APPEAL SUMMARY

Appeal ID: 15344	Project Address: 518 NE 20th Ave
Hearing Date: 7/12/17	Appellant Name: Brad Manchester
Case No.: B-007	Appellant Phone: 503-239-4600
Appeal Type: Building	Plans Examiner/Inspector: Jerry Engelhardt, Thomas Ng
Project Type: commercial	Stories: 6 Occupancy: R-2, A-2 Construction Type: III-B over I-A
Building/Business Name:	Fire Sprinklers: Yes - 20th and Glisan
Appeal Involves: Erection of a new structure	LUR or Permit Application No.: 17-134466-CO
Plan Submitted Option: mail [File 1]	Proposed use: multi-family house with tenant build out space

Intake Air from Parking Garage to Serve Emergency Generator: Hold for additional information.

JANTZEN APARTMENTS

LEVEL 1 PLAN - HVAC

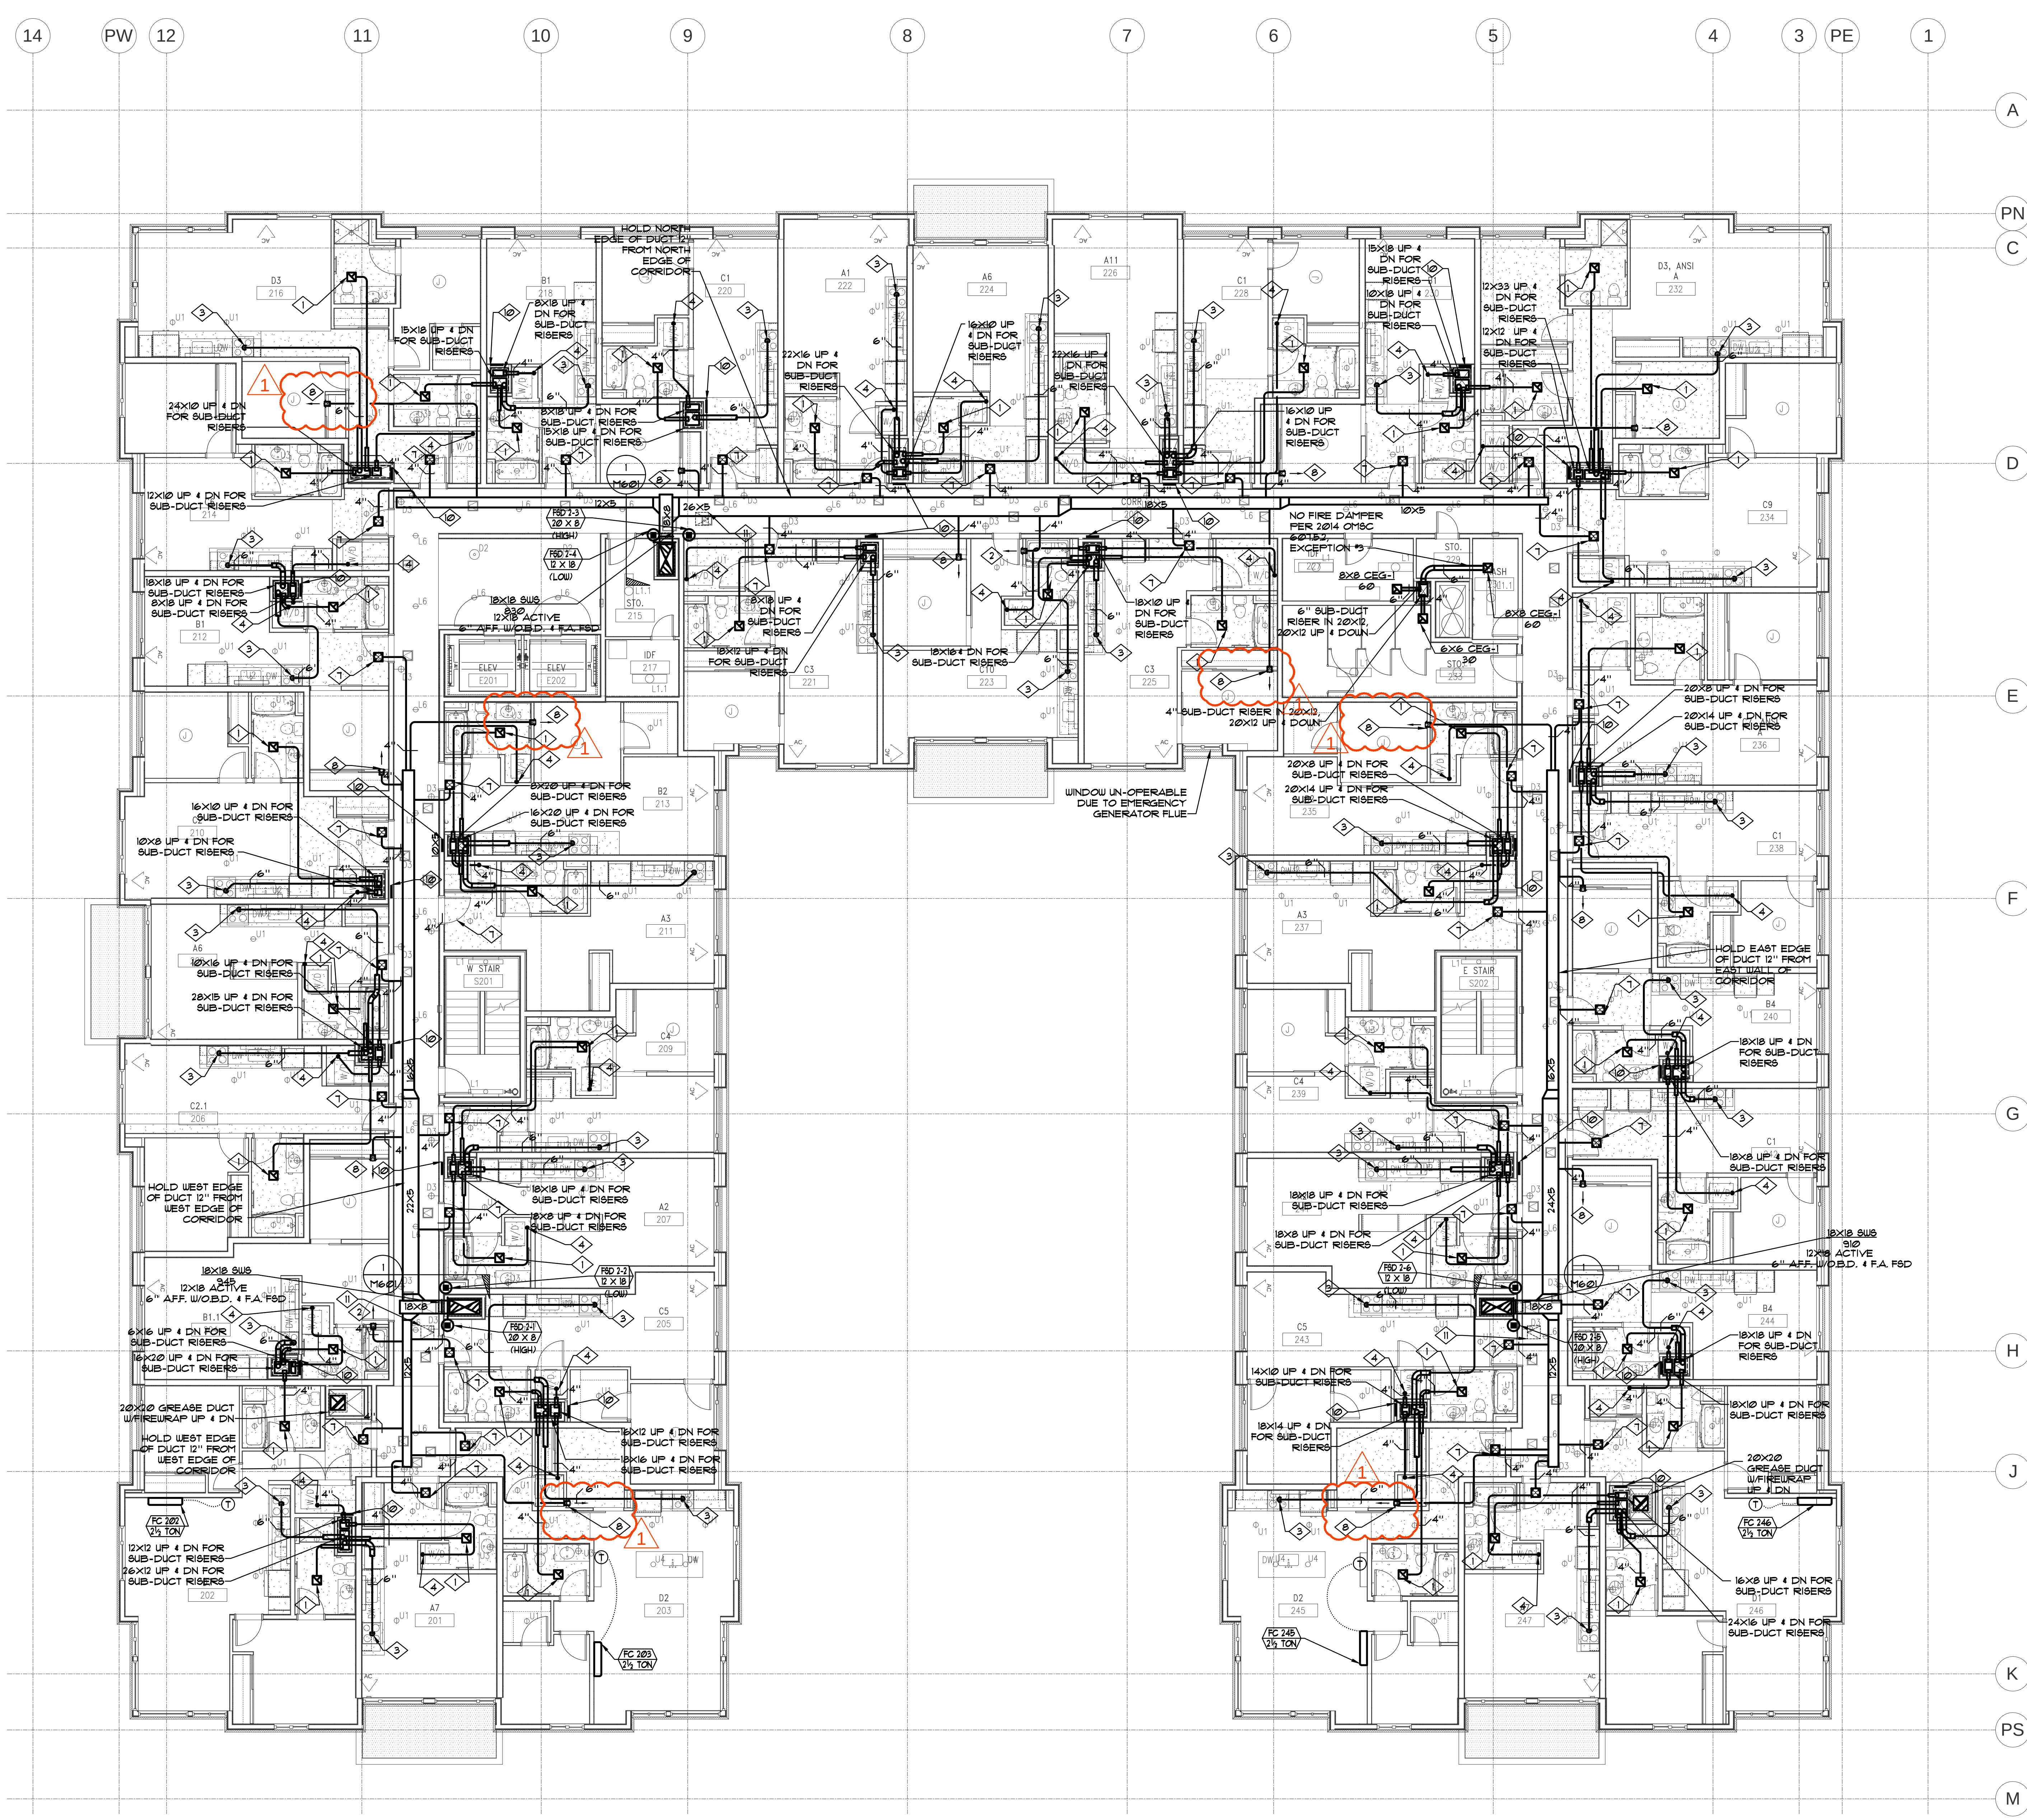
Code Section	OMSC 401.4.1, IBC / 27/#1, NEC / 7 / #1
Requires	Ventilation air supply be from outdoors or from a source outside the building by an exterior wall opening or from a source outside the building by a 2-hour fire-rated air transfer system.
Proposed Design	The proposed building is an A-2, B, R-2 & S-2 occupancy, mixed-use, 6-story, core and shell development containing below-grade parking, ground shell tenant-improvement space and 5-floors of residential apartments. This appeal would allow the emergency generator to use the parking garage ramp door for intake air. The on-site, indoor generator is located on the ground floor, above the parking garage ramp, with one exterior wall facing a courtyard, two interior walls with occupied spaces on the opposite side and the fourth wall facing the parking garage door & ramp, unobstructed. With the generator exhaust (radiator) directed out a louver on the sole exterior wall and to keep OMSC separation requirements of environmental air from mechanical air intakes, it is being proposed that the generator intake air come from a louver on the wall facing the parking garage door. The garage door will be perforated. The proposed design includes: - All air is exchanged within the driveway ramp. - Sprinklering will provided on both sides of the generator intake louvers. - No parking is allowed within 10 feet of the generator intake louver. - The generator exhaust and intake is separated by at least 10 feet.

Reason for alternative	Due to the relative location & configuration of the generator room and the proximity of the parking garage door, it is impractical to convey intake air from the building's exterior.
